SUBJECT: CALLAWAY PLANT, UNIT NO. 1 – REQUEST FOR ALTERNATIVE I4R-05 TO REACTOR VESSEL NOZZLE WELD EXAMINATION FREQUENCY REQUIRMENTS (EPID L-2018-LLR-0051)

SAFETY EVALUATION BY THE OFFICE OF NUCLEAR REACTOR REGULATION

REQUEST FOR ALTERNATIVE I4R-05 TO REACTOR VESSEL NOZZLE WELD

CALLAWAY PLANT, UNIT NO. 1

Figure 1 – B-HL Reactor Vessel Nozzle WJP Application

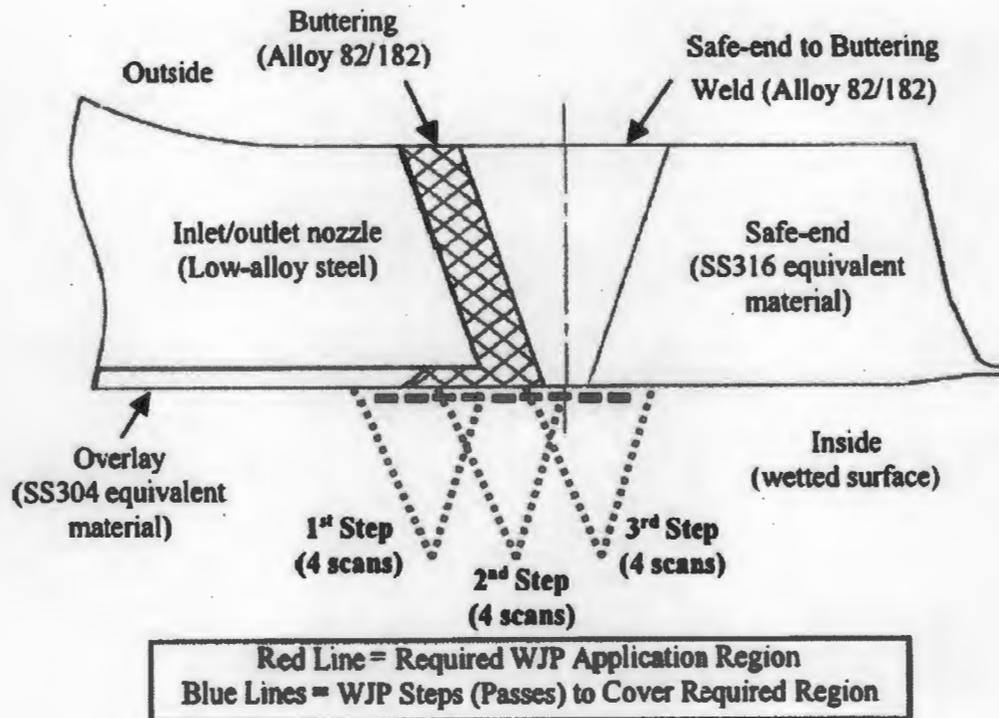
As discussed in paragraph 4.2.8.1 of MRP-335, Revision 3-A, the stress effect performance criterion provides the required peening coverage area. It is the full area of the susceptible material along the entire wetted surface under steady-state operation. Susceptible material includes the weld, butter, and base material, as applicable. The coverage shall be extended at least 0.25 in (0.64 cm) beyond the susceptible material (see the red or dashed line in Figure 1 below).

The licensee used eddy current testing to verify the dissimilar metal weld boundaries on the inside diameter of the pipe. The NRC staff found this to be a reliable methodology to determine the size of the weld on the inside surface of the pipe. The licensee also used a predetermined coverage scheme that accounted for the spray width from the WJP nozzle, spray overlap between passes, and spray coverage relative to the edge of the DMBWs on the inside surface. The licensee used a value of 13.4 mm to extend the coverage beyond the edge of the susceptible weld material on the inside surface on either side of the weld (see the blue or dotted lines of the 1st to 3rd Steps in Figure 1 below). This value exceeds the required 6.4 mm of MRP-335, Revision 3-A. The licensee further provided additional information demonstrating the quality controls over the software program and data collection used to verify the remote control and coverage requirements that were obtained by the spray nozzles. Therefore, the NRC staff finds the licensee met the coverage requirements of paragraph 4.2.8.1 of MRP-335, Revision 3-A, for the subject welds.
